ATTACHMENT B

AFFECTED TECHNICAL SPECIFICATION PAGES

LICENSE DPR-19/25

ComEd proposes to amend Appendix A, Technical Specifications, Section 3/4.6.K of Facility Operating Licenses DPR-19, DPR-25, DPR-29 and DPR-30. The amendment request changes the pressure temperature (P-T) curves, Figure 3.6.K-1 and associated Bases.

FIGURE 3.6.K-2

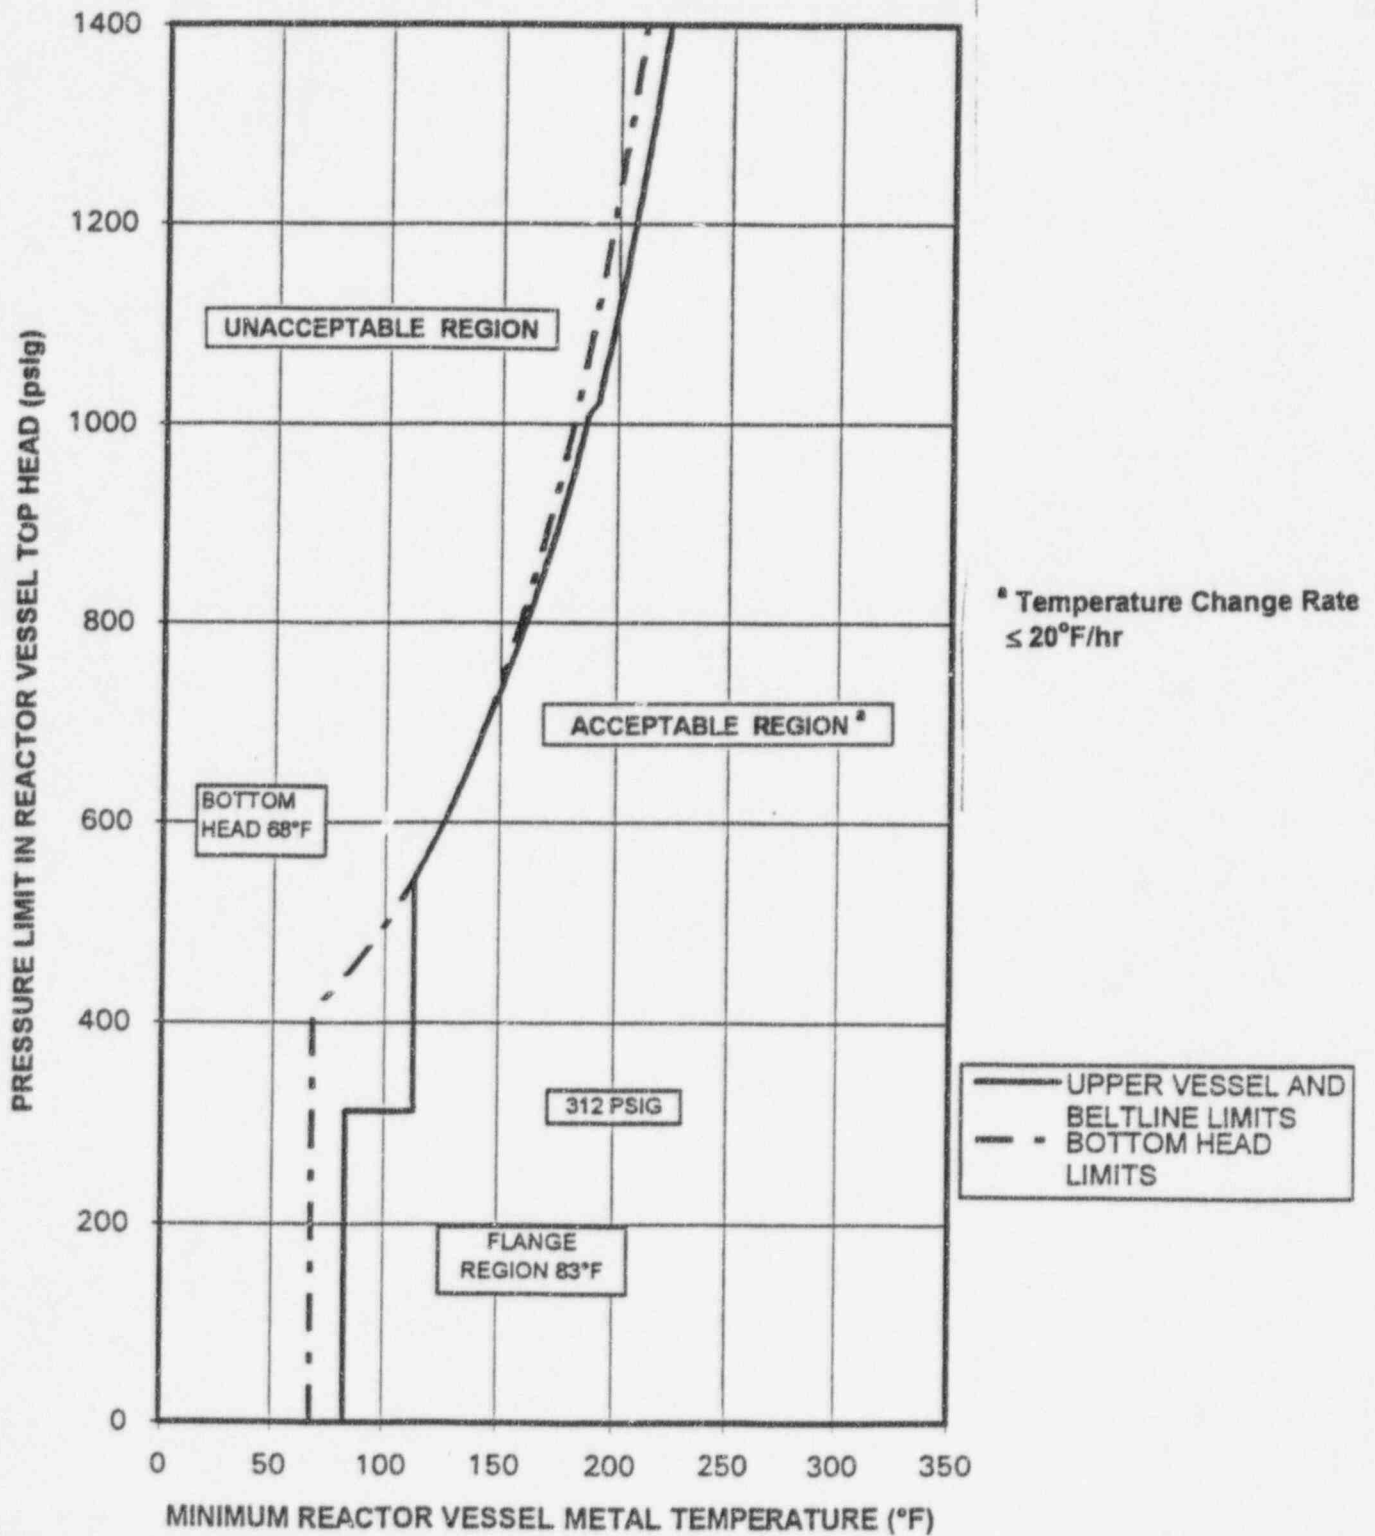
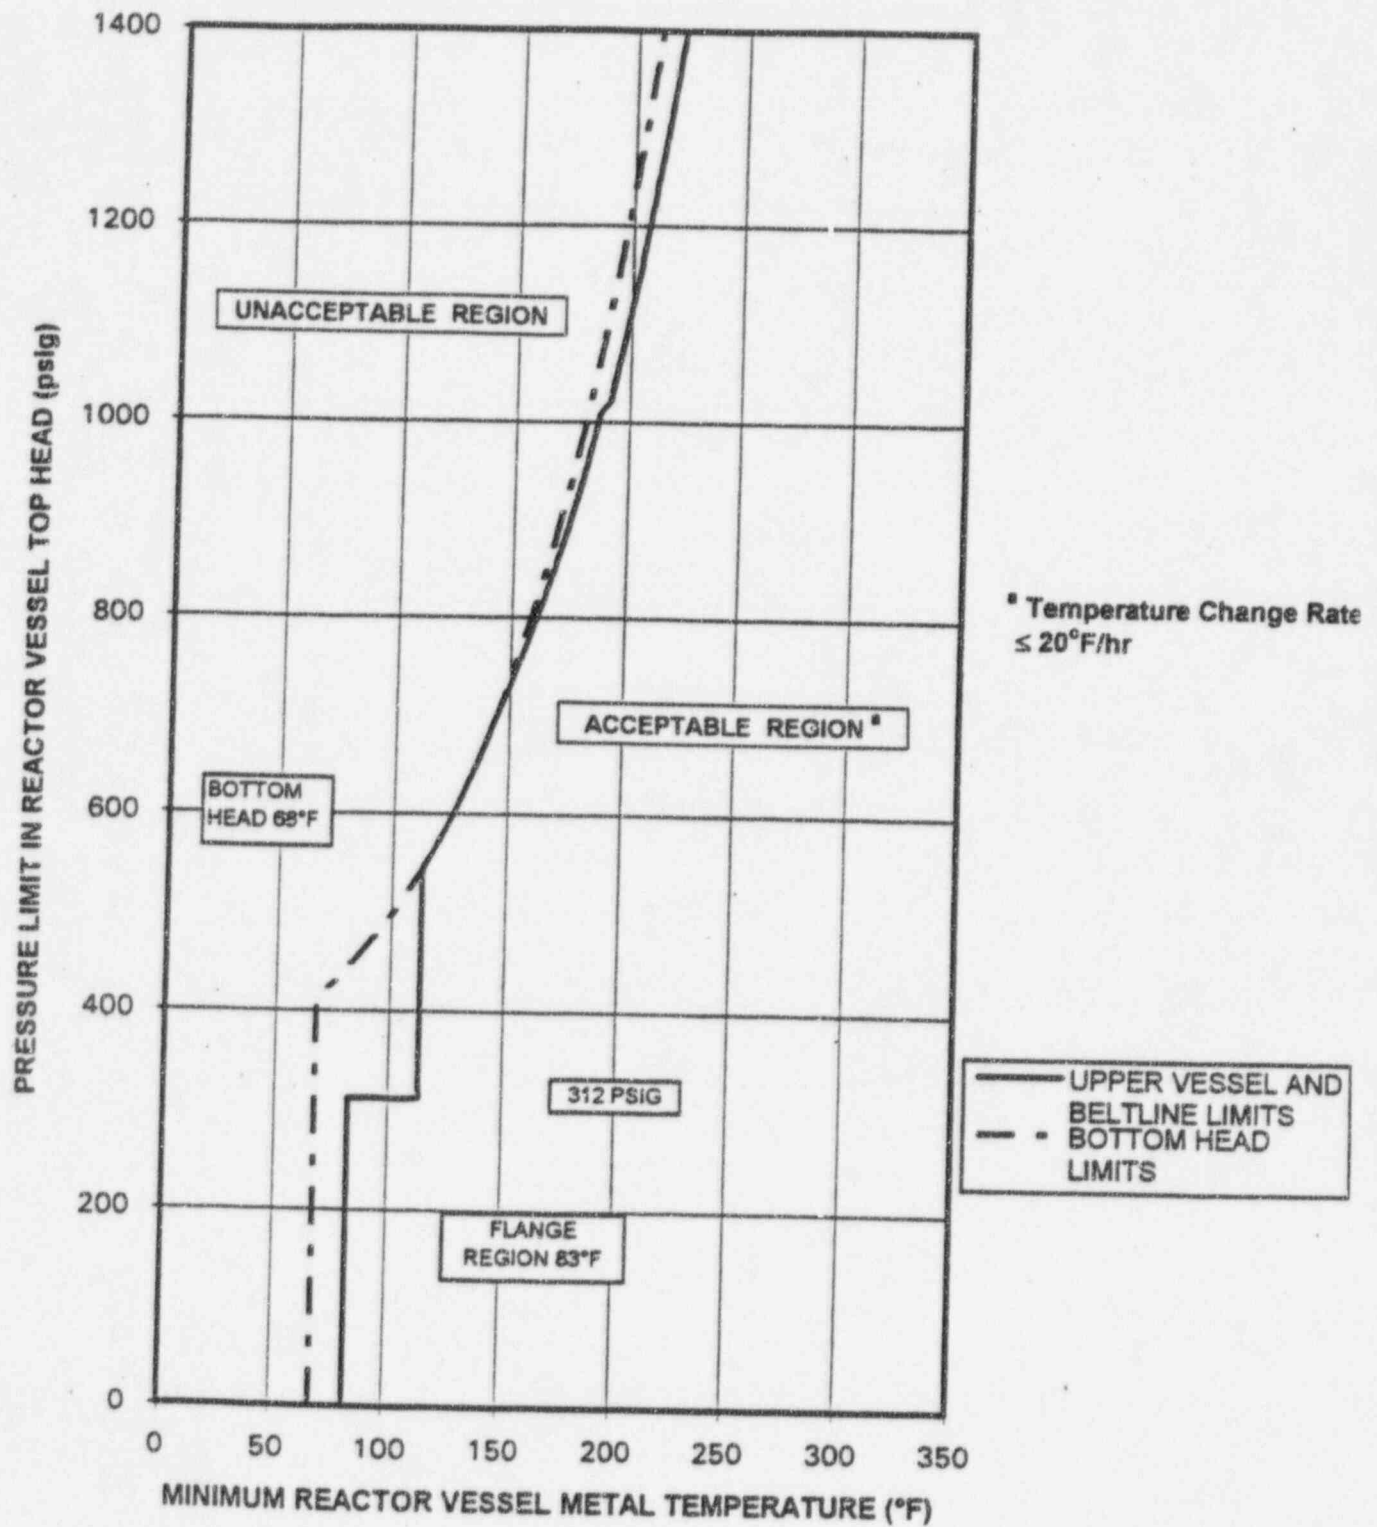
The proposed amendment reflect an update of the P-T curves to extend the operating limit to 22 EFPY. The revised curves are based on the latest NRC guidance along with actual data for the units. The new limits retain the margin of safety to the level expected for a new vessel, adjusted for irradiation effects as required by 10CFR, Appendix G, thereby maintaining a conservative margin of safety.

As indicated in Figure 3.6.K-1 through 3.6.K-3 for pressure testing, the minimum metal temperature of the reactor vessel shell is 83°F for reactor pressures less than 312 psig. This 83°F minimum boltup temperature is based on a RT_{NDT} of 23°F for the electrosag weld immediately below the vessel flange and a 60°F conservatism required by the original ASME Code of construction. The bottom head region limit is established as 68°F, based on moderator temperature assumptions for shutdown margin analyses. At reactor pressures greater than 312 psig, the minimum vessel metal temperature is established as 113°F. The 113°F minimum temperature is based on a closure flange region RT_{NDT} of 23°F and a 90°F conservatism required by 10CFR Part 50 Appendix G. Beltline curves as a function of vessel exposure for 18, 20 and 22 effective full power years (EFPY) are presented to allow the use of the appropriate curve up to 22 EFPY of operation.

As indicated in Figure 3.6.K-1 through 3.6.K-3 for pressure testing, the minimum metal temperature of the reactor vessel shell is 83°F for reactor pressures less than 312 psig. This 83°F minimum boltup temperature is based on a RT_{NDT} of 23°F for the electroslag weld immediately below the vessel flange and a 60°F conservatism required by the original ASME Code of construction. The bottom head region limit is established as 68°F, based on moderator temperature assumptions for shutdown margin analyses. At reactor pressures greater than 312 psig, the minimum vessel metal temperature is established as 113°F. The 113°F minimum temperature is based on a closure flange region RT_{NDT} of 23°F and a 90°F conservatism required by 10CFR Part 50 Appendix G. Beltline curves as a function of vessel exposure for 18, 20 and 22 effective full power years (EFPY) are presented to allow the use of the appropriate curve up to 22 EFPY of operation.
